**CALIFORNIA REGIONAL WATER QUALITY CONTROL BOARD
LAHONTAN REGION**

**SUBJECT: PEER REVIEW OF PACIFIC GAS & ELECTRIC
COMPANY'S 2007 GROUNDWATER CHROMIUM
BACKGROUND STUDY, HINKLEY COMPRESSOR
STATION, SAN BERNARDINO COUNTY**

Appendix 1: Copies of Peer Reviewers' Comment Letters

Figure 1 Map of Cr(T) and Cr(VI) Sampling Results; Background Study

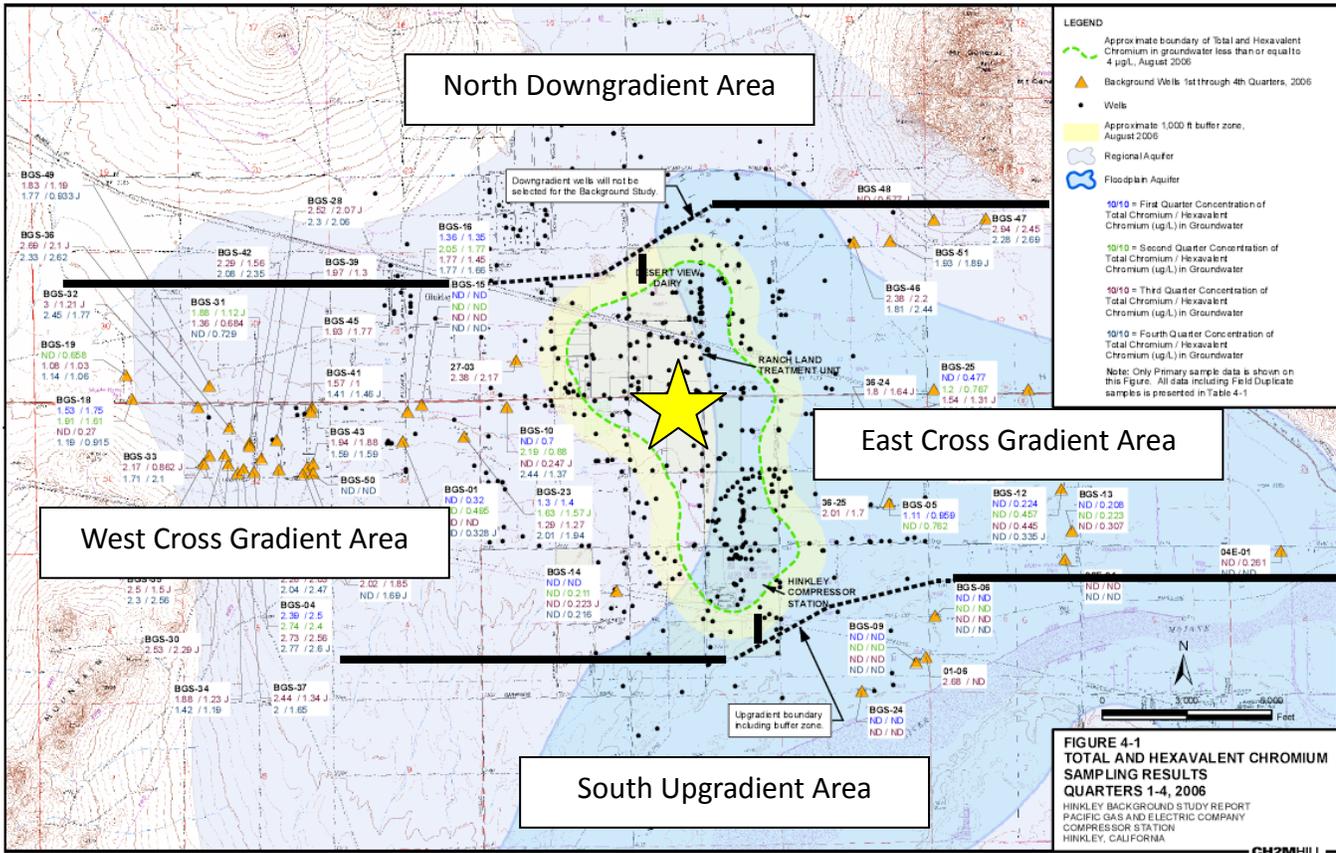
Comments: The wells used for the background study reported in the CH2MHILL (2007) report show an inconsistent pattern of well sampling as shown above. The Hinkley Valley in the background study area can be divided into five main areas (see attached **Figure 1**; based on the Figure 4-1; CH2MHILL 2007 Study). The five main areas are as follows: Core Area, South Upgradient Area, East Cross Gradient Area, West Cross Gradient, and North Downgradient Area. Across these there is an Upper and a Lower Aquifer. These aquifers are separated in most areas by a confining clay aquitard, called the Blue Clay, except as noted below.

Of the areas shown in **Figure 1**, the South Upgradient Area is the most likely to provide natural or background levels of Cr(T) and Cr(VI). Samples from the Mojave River, although more than one mile from the PG&E facilities, may show less anthropogenic influences for background samples of Cr(T) and Cr(VI) for the region.

In addition to the issues listed above regarding the wells being screened in more than one aquifer, the chosen set of 'background' wells are not located adequately upgradient and outside the range of influence of actively pumping (historically or currently) extraction wells (which could be drawing the Cr(VI) plume in an upgradient direction) to be representative of background conditions. Virtually all of the chosen wells are located in a cross gradient position from the main plume with poorly defined cross gradient Cr(T) and Cr(VI) plume boundaries. As noted, well data should reflect specific aquifer zones, not mixed zones. Given the eight decades of intense agricultural pumping, it is possible that with preferred flow pathways (high permeability zones due to lithologic characteristics or geologic faults (Lockhart) or other potential conduits), some of the Cr(T) and Cr(VI) from the Core Area may have migrated over the past decades toward the east or west into the East Cross Gradient Area or the West Cross Gradient Area, respectively (see **Figure 1**).
